*Proceedings of the Madras Government, Public Works Department,
24th October 1876. No. 2,835.*

No. 357. Read the following letter from the President of the Municipal Commission, Tanjore, through the Financial Department, dated 12th October 1876, No. 195:—

12753
Superintending Engineer's Office,
Bangalore, 26 May 1876

In returning the papers
which accompanied your letter of
3rd March, I have the honor to inform
you that I have looked over Mr. Gairdner's
report for the supply of Bangalore from
the Padavara.

Regarding the Channel Reservoir
and Filter 39

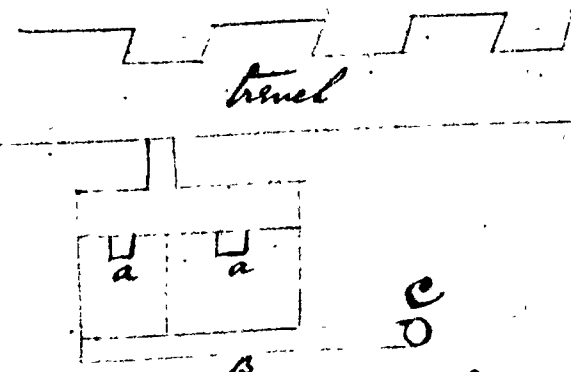
The Channel from the reservoir
to the Vadavoor will be about a
mile or more and a half long
and 3 feet broad and must be
cut on a level with the bed of
the river all the way and slightly
sloped on both sides and have a
fall towards the reservoir and
my reservoir will be 10 feet
below the Channel.

My reservoir will be 100 feet
square and 10 feet deep which
will be quite sufficient for the
water to be pumped into the trench
as my reservoir will be filled as
fast as I pump the water out.

I will have a self acting
gate at the end of the Channel near
the Vadavoor in case the river runs
low. The filter will be situated
at

at the Northern side of the reservoir
 and will be below the level of the
 trench so that the water from the
 trench will of itself pass through
 my filter and from thence through
 a channel into a well near the
 engine to be pumped for drinking
 purposes into the town. I will
 have two valves between the
 trench and my filter to allow water
 in the filter only when required.
 The trenches of both Fort
 and the small Fort tanks will
 contain 103,500,000 gallons of water
 and therefore without calculating
 the water which will come from
 the Chapin tank tank it
 will take me from 40 to 50 days
 to fill the whole or half that
 time if the engine is worked
 day and night and including
 the water from Chapin tank
 tank the trench can probably
 be filled in a number of that
 time.

The filter will be 100 yards long
 100 yards
 broad and 3
 feet high. This

filter reservoir
 will be divided
 into 2 parts,
 each part having a valve leading
 into the trench marked a. a. B.
 is a channel which brings the
 filtered water to a well c. from
 whence the engine will pump
 it into the small Fort tank.

The filter reservoir must
 be divided into two, so I will
 only use half of the above re-
 servoir for 15 days while the
 other half is cleaned and vice
 versa.

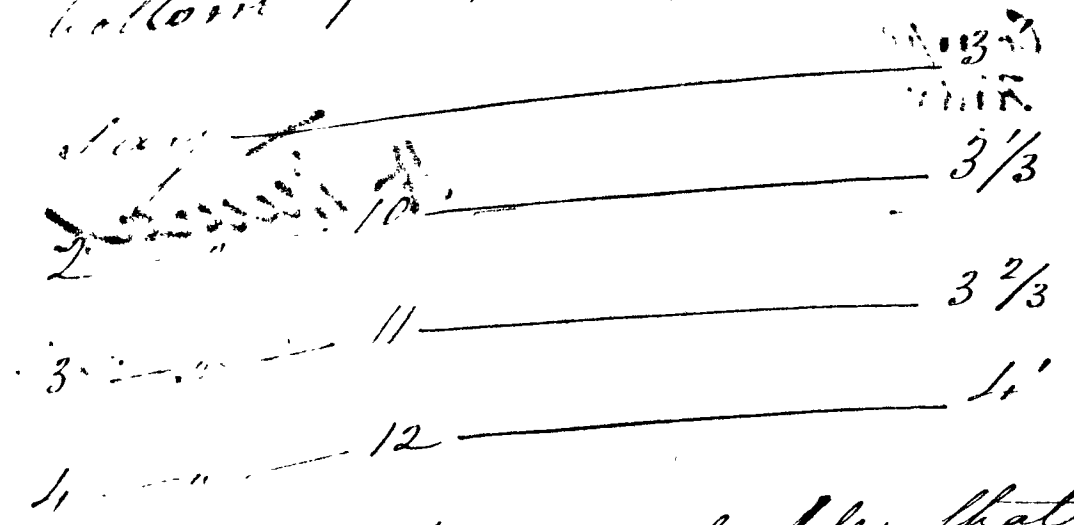
99
channel at about 109. If
the bed is very deep and
the fall considerable a
dam may be raised to
as 5 feet above bed and

would be put
in it at that
level so as to
raise the full
unpooled bed
permanently
4 or 5 feet at
the off take of the Channel.

The Channel will
cross another ugly drainage
below the Manjipetty
village, it may probably
be crossed by a similar
work to avoid deep cutting.
The Channel will probably
follow the dotted black pencil
line

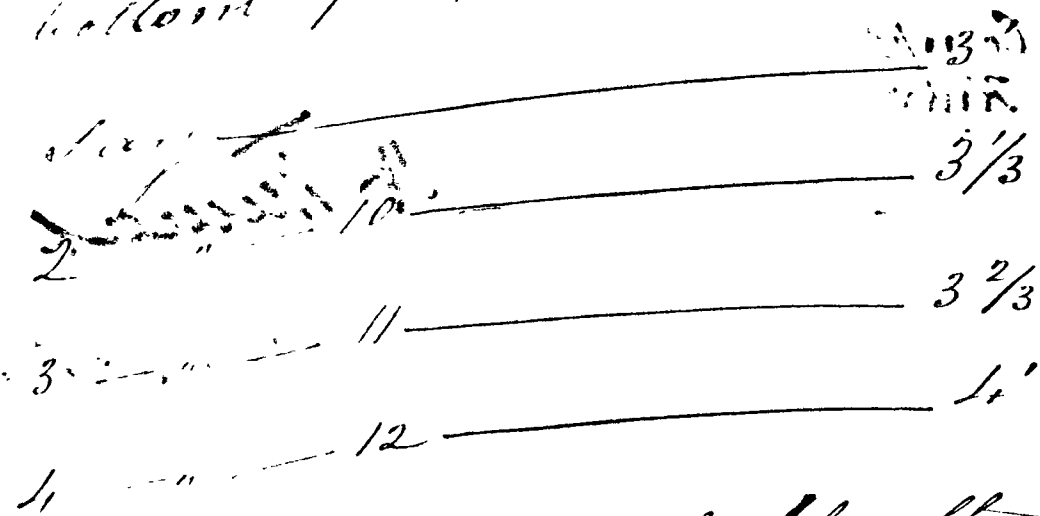
6. To prevent
breaches the channel
had better be cut about
 $3\frac{1}{2}$ or $4'$ in the solid and
as little drainage as pos-
sible should be allowed
to pass directly into the
Channel; Catch drains
above or south of the
Channel should intercept
direct drainage and be
passed into the Channel
at spots specially prepared

to receive it; better soil
being laid down below than
appears on the surface
but if not the velocity
in the channel should not
exceed between 2 and 3
feet per second and hence a depth
of more than $1\frac{1}{2}'$ should
not be allowed.

7. The section of
the channel may be as
follows the side slopes
being $1\frac{1}{2}$ to 1, 1st mile
bottom 9' depth of water
